# HISTORIC AND DESIGN REVIEW COMMISSION

**HDRC CASE NO:** 2017-467  
**ADDRESS:** 423 N HACKBERRY ST  
**LEGAL DESCRIPTION:** NCB 576 BLK 15A LOT N 30.32 FT OF 12  
**ZONING:** RM-4 H  
**CITY COUNCIL DIST.:** 2  
**DISTRICT:** Dignowity Hill Historic District  
**APPLICANT:** John Brearley  
**OWNER:** John and Irene Brearley  
**TYPE OF WORK:** New construction of a 2-story single family home  
**REQUEST:**

The applicant is requesting conceptual approval to construct a new two-story single family home on the vacant lot at 423 N Hackberry St.

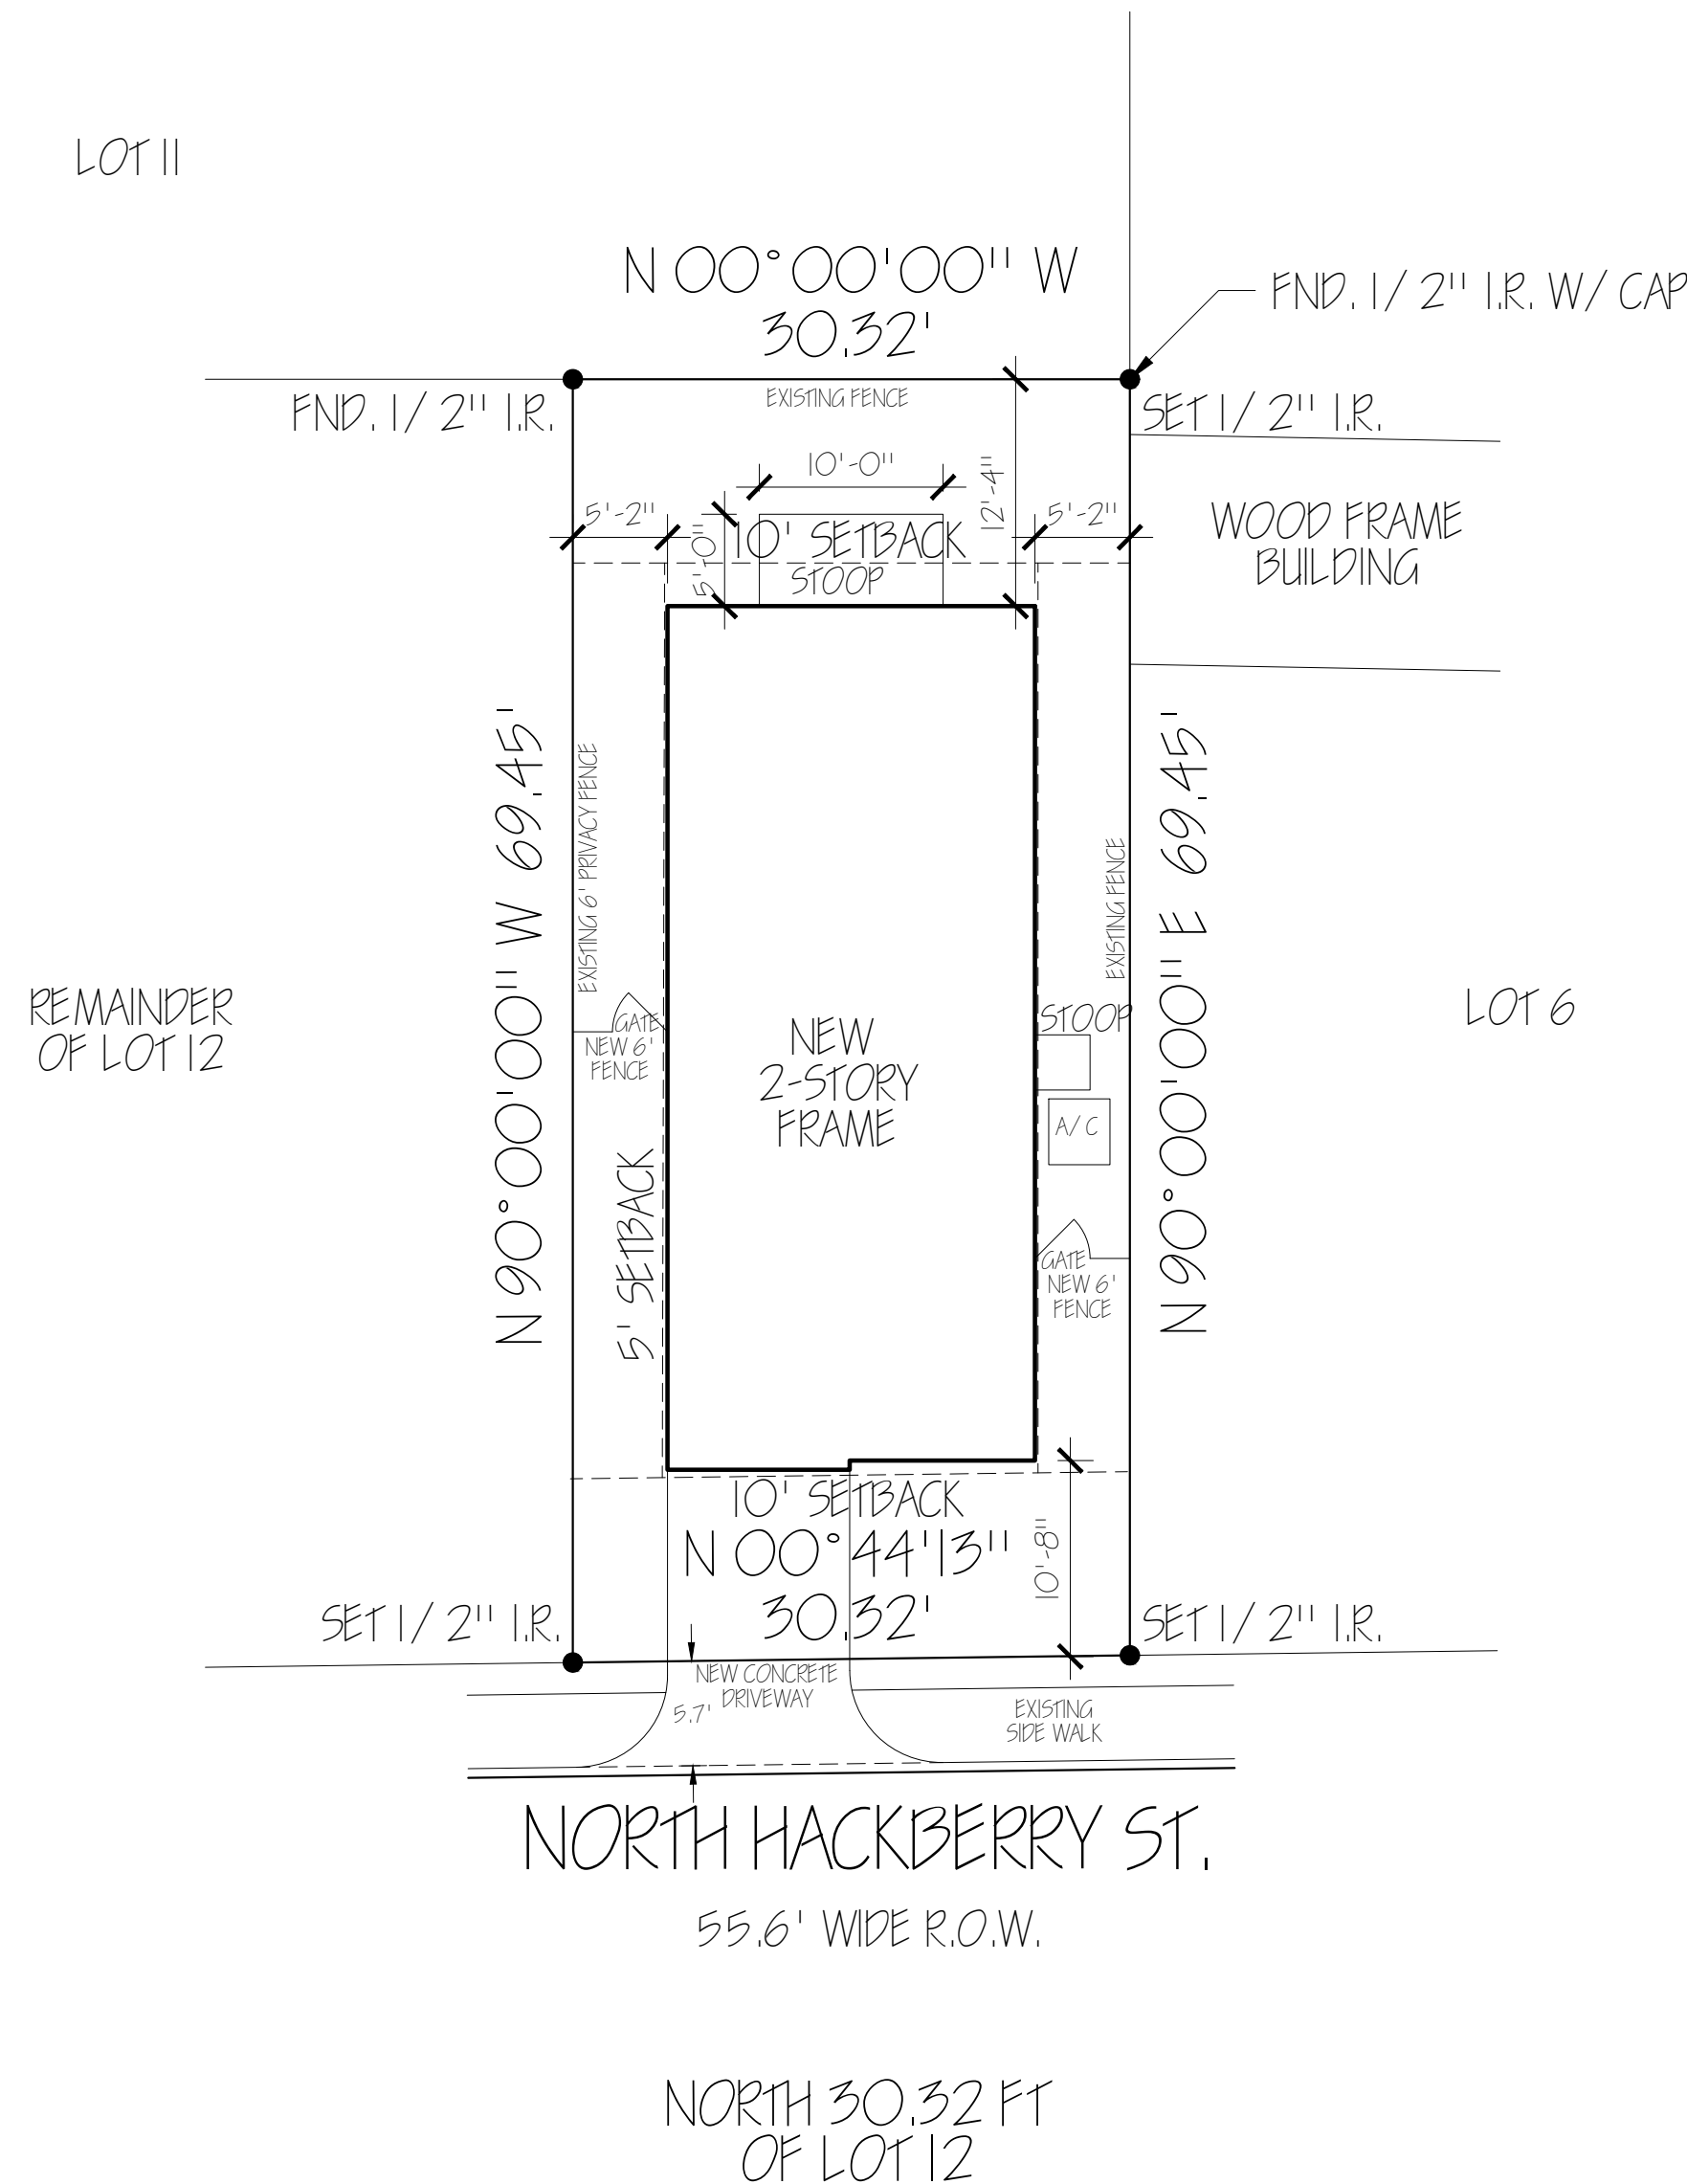
- d. **SETBACKS & ORIENTATION** – According to the Guidelines for New Construction, the front facades of new buildings are to align with front facades of adjacent buildings where a consistent setback has been established along the street frontage. Additionally, the orientation of new construction should be consistent with the historic example found on the block. The applicant has noted a setback of approximately 10'-8" from the front façade to the front sidewalk. The historic structure immediately to the north of 423 N Hackberry features a side setback from the sidewalk of approximately 20'-0". This is the only historic structure that partially fronts N Hackberry on this block. According to a 1951 Sanborn Map, three 1-story residential structures occupied this block of N Hackberry and all featured a minimal front setback. Based on the historic development pattern and current context of the block, staff finds the proposed setbacks appropriate.

- l. LOT COVERAGE – Per the Guidelines, the building footprint for new construction should be no more than fifty (50) percent of the size of the total lot area. The proposed new construction does not meet this Guideline.

- p. DRIVEWAY & PARKING – The applicant has proposed a new front concrete driveway measuring approximately 10’-8” in length and approximately 10’-0” in width. The concrete terminates at the front façade of the proposed new structure’s carport and transitions into crushed granite. According to the Historic Design Guidelines, new garages should follow the historic pattern of similar structures along the streetscape or district for new garages and outbuildings. Historic garages and outbuildings are most typically located at the rear of the lot, behind the principal building. There is no historic precedent for an attached garage in the Dignowity Hill Historic District. The development pattern in the Dignowity Hill Historic District is most commonly for driveways to extend through the front yard to the side and rear yard of historic properties. Staff does not find the proposed front-loaded parking and driveway location to be consistent with the Guidelines or with the development pattern of the district.

- r. FENCING – The applicant has noted per the site plan that a new privacy fence measuring 6’ in height is to be installed in the side and rear yard behind the front façade. Staff finds the proposed location and height appropriate; however, the applicant is to submit a detail of the proposed fence, including materiality and design, when returning to the HDRC for final approval.

1. That the applicant provides information noting the setbacks of adjacent historic structures on a contextual site plan.
2. That the applicant reduces the proposed height through the shortening of the second story or the lowering of the top plate height to produce an overall height that is comparable with the heights of neighboring historic structures.

5. That the applicant explores ways to construct a driveway along the side of the proposed new construction as noted in finding p.
6. That the applicant introduces window sizes and proportions that are more consistent with the Historic Design Guidelines, the OHP Window Policy Document, and adjacent historic structures to the right and left elevations as noted in finding i.
